# Agenda

## Planning Committee

Wednesday 4 October 2023 6pm

<b>PC2310-2 .....MARINE TERRACE, NO. 96 (LOT 123), FREMANTLE – ALTERATIONS TO EXISTING HERITAGE BUILDING AND A TWO STOREY SINGLE HOUSE – (CM DA0107/23).....</b>	<b>36</b>
<b>PC2310-3 HIGH STREET, NO. 185 (STRATA LOT 1), FREMANTLE – CHANGE OF USE TO FOUR SERVICED APARTMENTS AND ALTERATIONS TO EXISTING BUILDING – (CM DA0153/23). </b>	<b>53</b>
<b>PC2310-4 JACKSON STREET, NO. 20 (LOT 1), NORTH FREMANTLE – ADDITIONS AND ALTERATIONS TO EXISTING SINGLE HOUSE – (JD DA0199/23) .....</b>	<b>61</b>
<b>PC2310-5 MANNING STREET, NO. 5 (LOT 28) FREMANTLE – VARIATION TO DA0100/22 (TWO STOREY ADDITIONS AND ALTERATIONS TO EXISTING SINGLE HOUSE) (ED VA0012/23) .....</b>	<b>68</b>
<b>PC2310-6 .....SOLOMON STREET NO. 83 (LOT 62), FREMANTLE – TWO STOREY SINGLE HOUSE WITH BASEMENT – (CM DA0160/23) .....</b>	<b>86</b>

**Figure 3** – Extent of overlooking to the east.

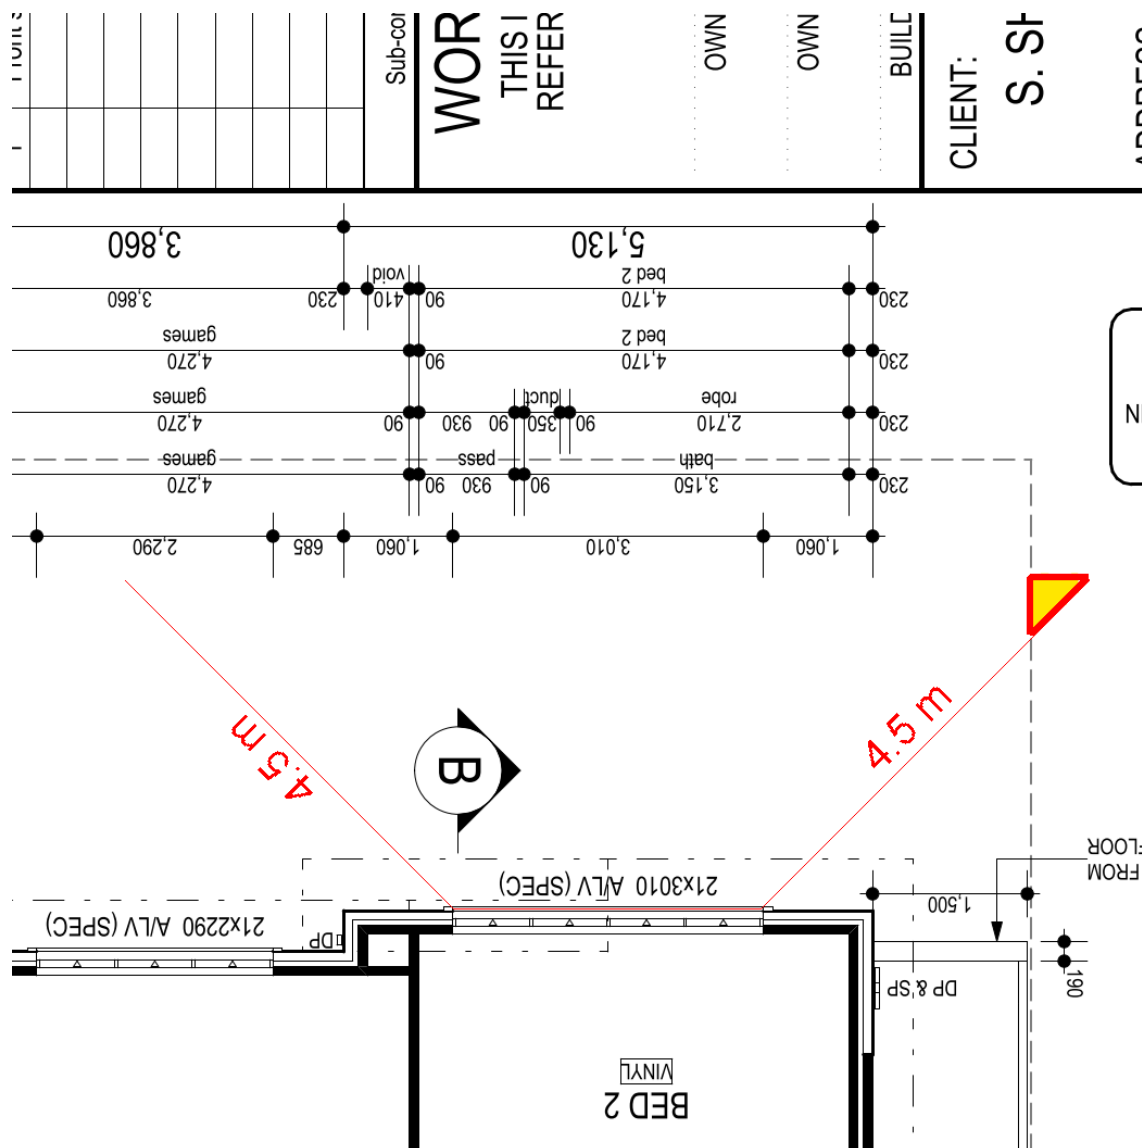
- The variation is considered minor and will not result in a significant loss of privacy on the adjoining lot to the east (refer Figure 3 below).
- The overlooking will not be directed into any major openings and is confined to a small portion at the rear of the opposing lot.
